City of Albuquerque Public Works Department

SUBJECT: Sparton Coors Road Facility

TO:	Norman Gaume/City of Albuquerque
FROM:	Mike Bitner/CH2M HILL Amy R. Halloran/CH2M HILL
DATE:	December 4, 1995
SUBJECT:	Sparton Technology, Inc. Coors Road Facility
PROJECT:	131048.A3.01
SUMMARY

Proposed Critical Management Areas in the Albuquerque Area

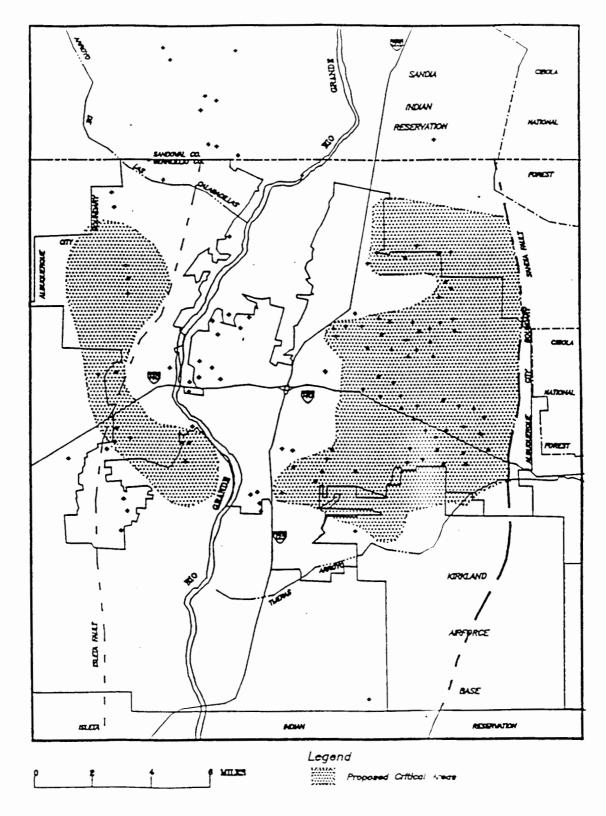
The New Mexico State Engineer Office has issued the report of a staff task force charged with recommending changes in groundwater pumping administration in the Albuquerque area. Their recommendations include establishing Critical Management Areas (CMA) within which no new wells would be allowed. Again, the Sparton Reaction turns the truth on its head. The attached map entitled "Proposed Critical Management Areas in the Albuquerque Area" shows that the Sparton area is outside of the proposed CMA. <u>The Sparton area is located precisely where the task force recommends new wells be allowed; adjacent to the river</u>. In contrast to the Sparton Reaction statement quoted at the beginning of this section, were it not for the Sparton contamination, the Sparton area would be a particularly attractive location for the new City wells that will be required. Wells could be permitted there, but not within most of the City's current groundwater production areas.
